8568B-04A

S E R V I C E N O T E

HP 8567A Spectrum Analyzer
 HP 8568A Spectrum Analyzer
 HP 8568B Spectrum Analyzer

Frequency Spur Correction

Figure 1. Component Locations

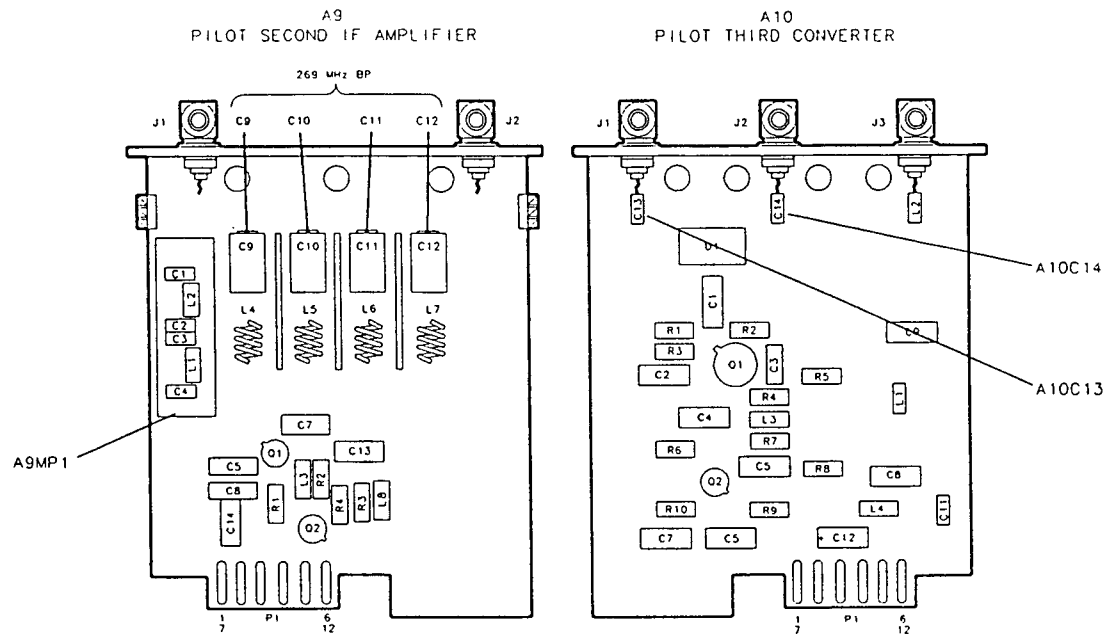
Signals from the A23 RF Converter Assembly feed through the A9 Pilot Second IF Amplifier Assembly and mix with the A10 Pilot Third Converter Assembly. This prevents the spectrum analyzer's meeting specifications for spurious responses (75 dB below -40 dBm total signal power at the input mixer).

This condition generates two families of spurs:

$(5 + 20 \times N)$ MHz, and $(12 + 20 \times N)$ MHz, where N equals the harmonic number of the 20 MHz Comb Generator

1. Separate the two instrument sections and set the IF-Display section aside.
2. Remove the two rear feet and the bottom cover from the RF section.
3. Using a #1 pozidrive screwdriver, remove the 4-40 screws from around the A9 Pilot Second IF Amplifier and the A10 Pilot Third Converter Assemblies. Remove these assemblies from the instrument and place them on a static-free work surface.
4. Solder A9MP1 (HP part number 7100-1304) to the ground plane as shown in Figure 1.

The shield is installed over the A9 lowpass filter. First remove the upright shield between this filter and A9C9 and A9L4, if present.

5. Install the two 10 pF capacitors on the A10 assembly. See Figure 2.
 - a. Solder one lead of A10C13 to A10J1 and the other lead to the ground plane.
 - b. Solder one lead of A10C14 to A10J2 and the other lead to the ground plane.
6. Install the A9 and A10 assemblies into the RF section.
